**EIS Coal Seam Gas Field
Environmental Values
and Management of
Impacts**

The respondent comments provided in this section have been collated from all stakeholder submission comments relating to EIS Section 6 EIS Coal Seam Gas Fields Environmental Values and Management of Impacts. Please refer to **Attachment A** for copies of all submissions received.

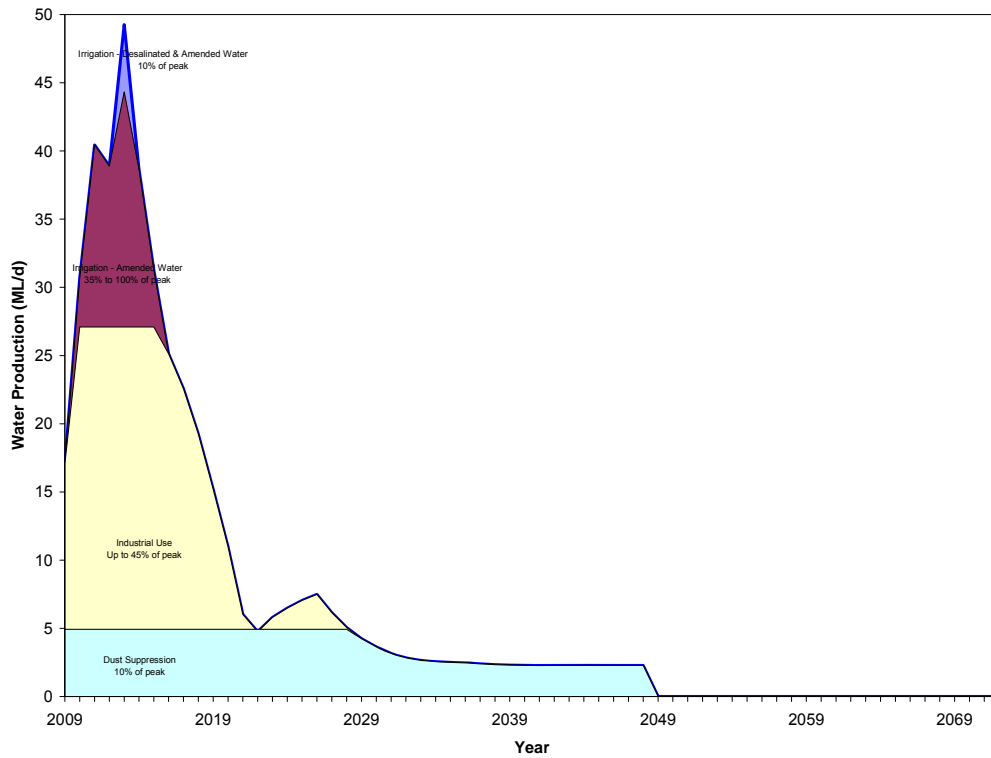
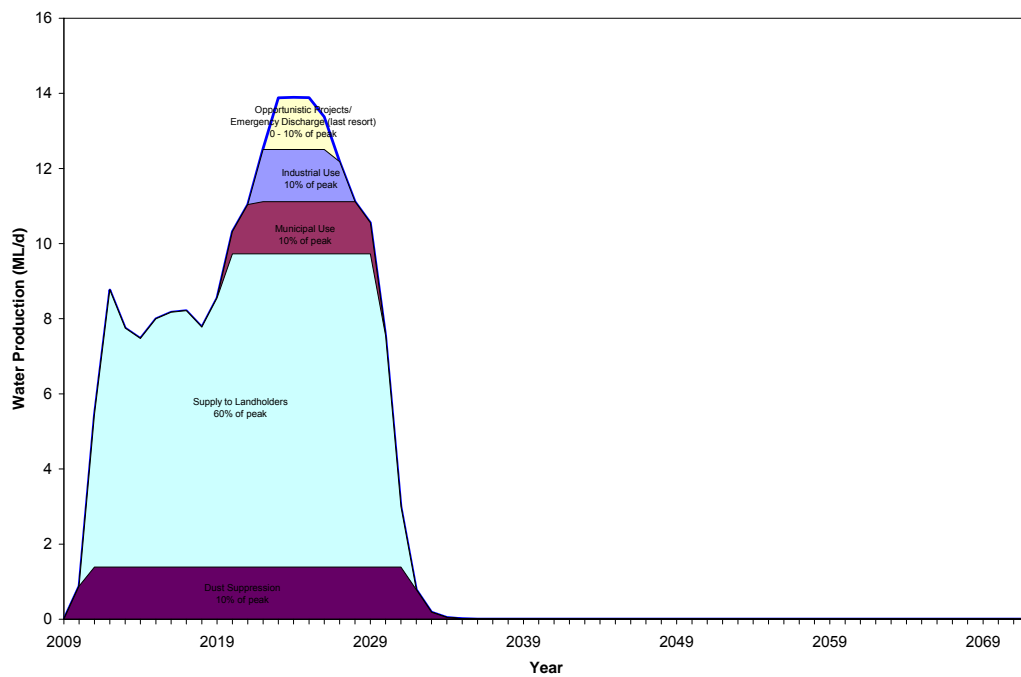
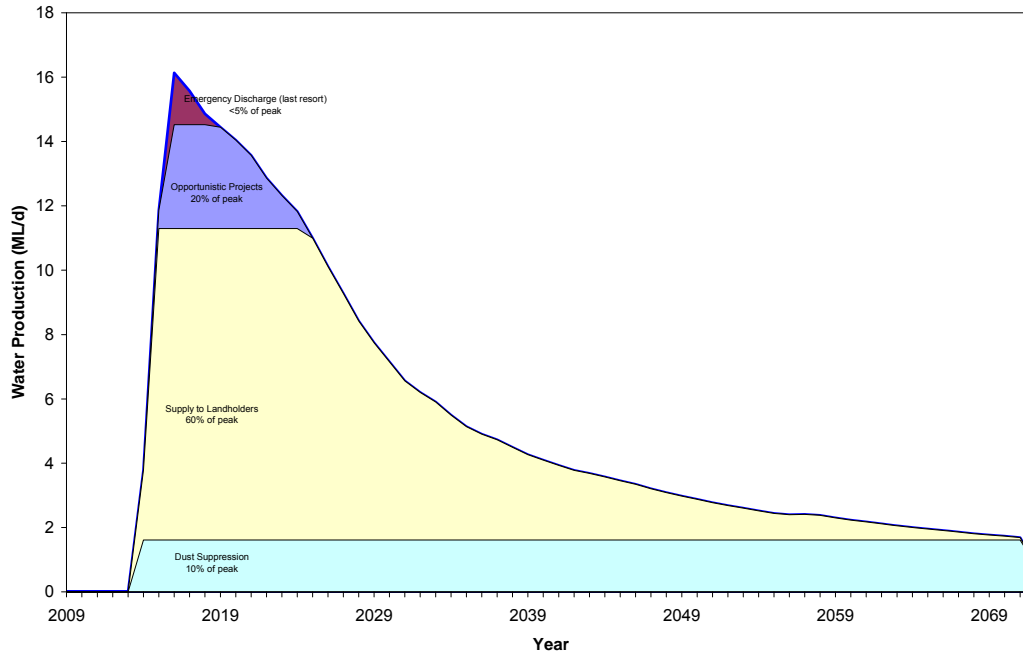
Department of Environment and Resource Management requested to clarify the statement in paragraph 2: "...it is expected that the same environmental values will apply to all streams in the catchment". This is also reflected in Table 6.5.1, but conflicts with the statement in Sect. 6.5.6 Summary of Findings (p6.5.21): "...baseline assessment has indicated that the existing water quality of surface waters is variable..."

- For Fairview, the AW management options consist of (in order of preference): dust suppression, industrial supply (via discharge of desalinated water to the Dawson River for downstream industrial users), irrigation of tree plantations using amended water and irrigation of forage crops using desalinated and amended water.

- For Roma, the AW management options consist of (in order of preference): dust suppression, supply of desalinated and/or amended water to local landholders, municipal use, industrial use, opportunistic projects, and as a measure of last resort, discharge of desalinated water to Bungil Creek.

- For Arcadia, the AW management options consist of (in order of preference): dust suppression, supply of desalinated and/or amended water to local landholders, opportunistic projects and as a measure of last resort, discharge of desalinated water to Lake Nuga Nuga.
